A Letter of Difference letter

This letter is to provide the difference in two main board (Basic: MNX22I1-MAIN_V6R1, Alternative: MNX_22I1-V9R1) which are used for Bluetooth headset model, WEP570.

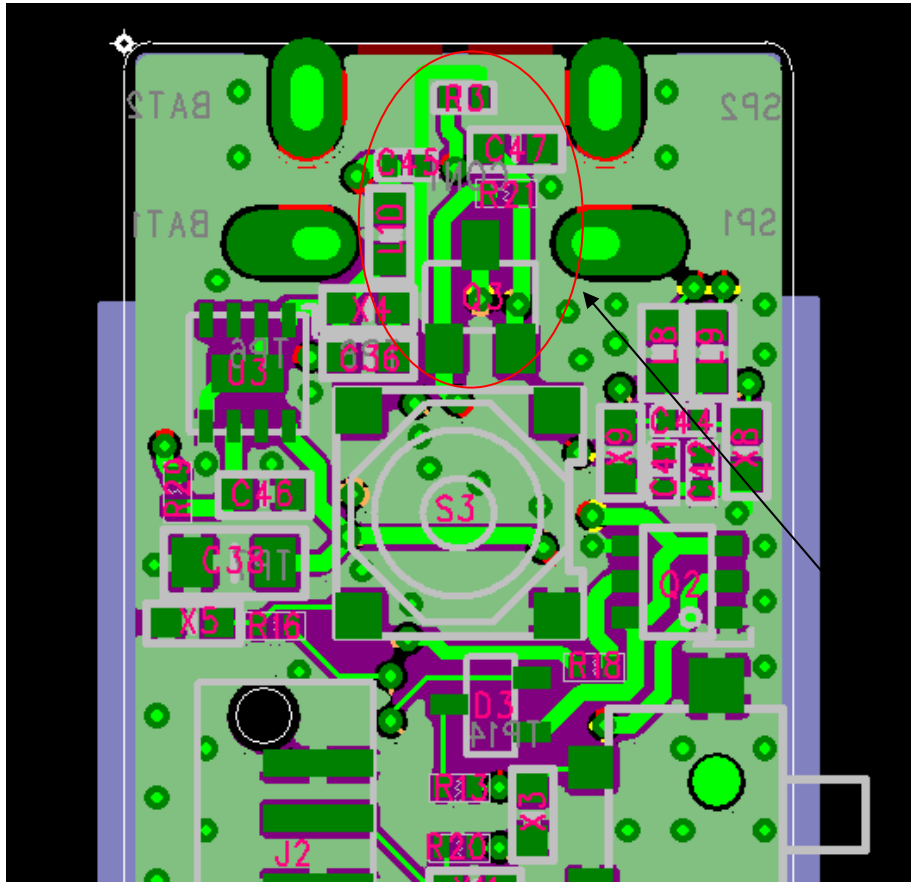
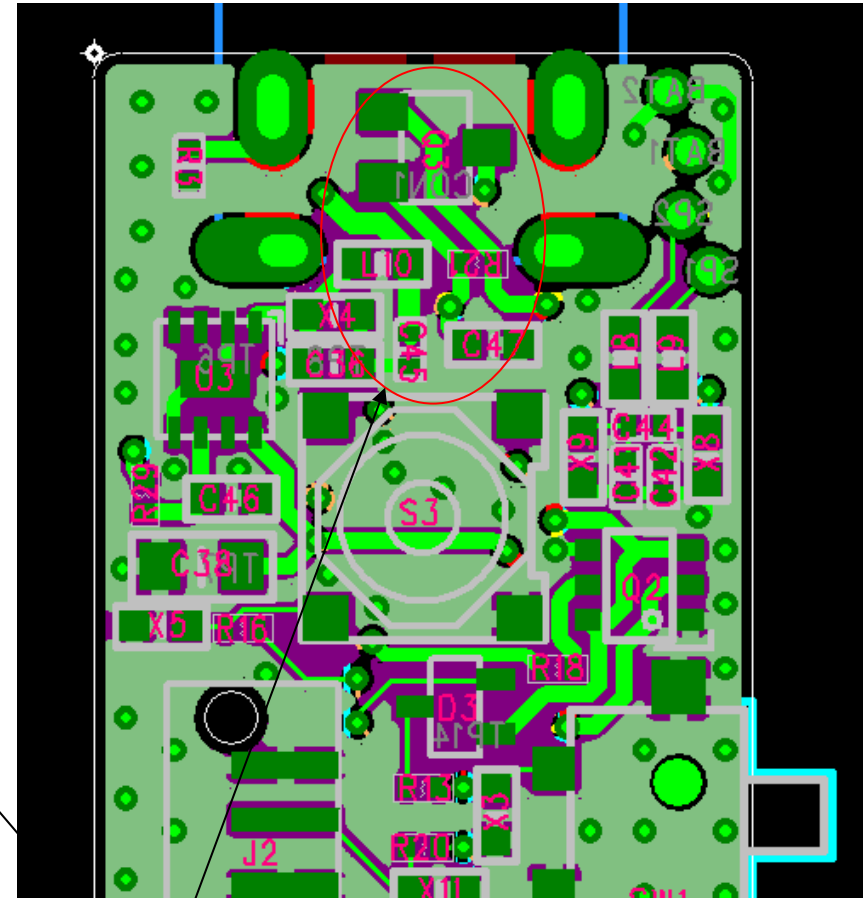
- MFB key: The alternative main board, MNX_22I1-V9R1 has more Q3, L10, R21, C45, R3.
- BAT solder pad: In MNX_22I1-V9R1, BAT solder pad is moved to right side and changed to through hole.

MFB key have interference.
In V9R1 have move Q3,L10,R21,C45,R3

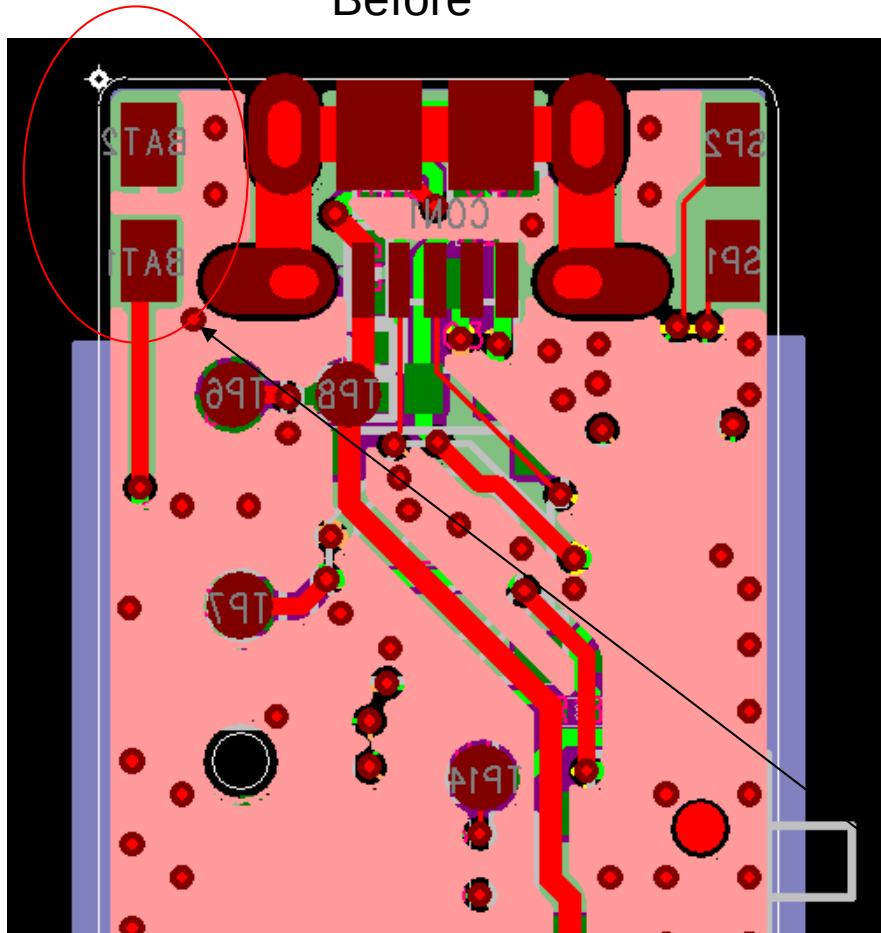
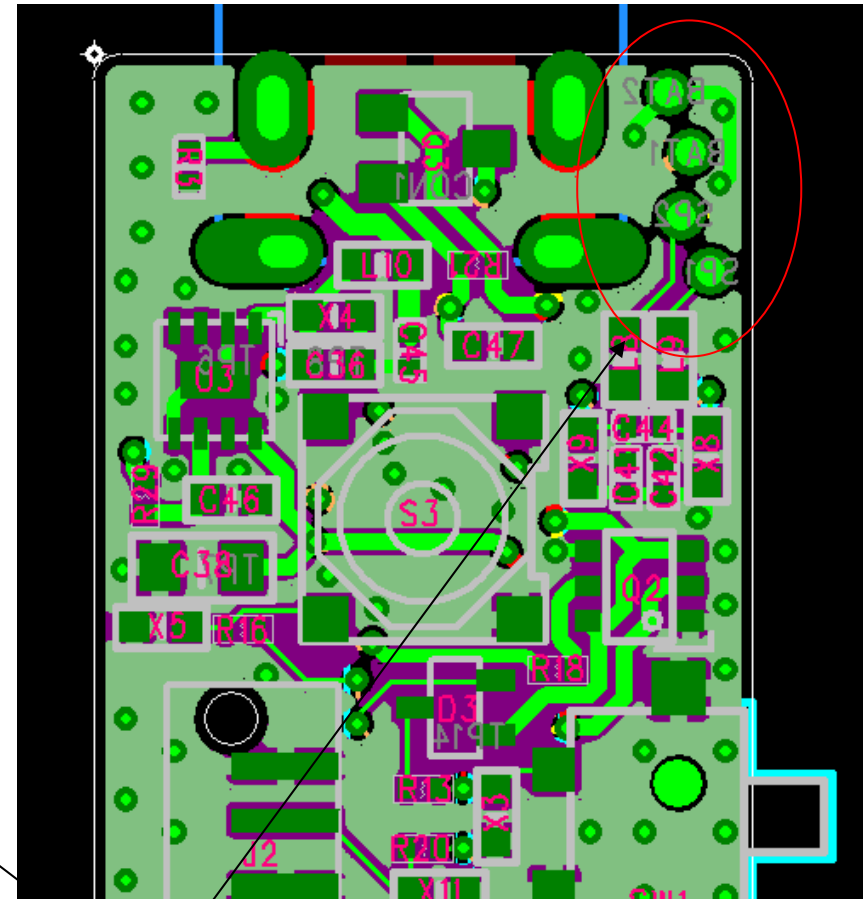
BAT solder pad have interference usb cover.
In V9R1 we have move BAT solder pad to right side
and change to through hole.

All soldering pads have 0.5mm distance from edges.
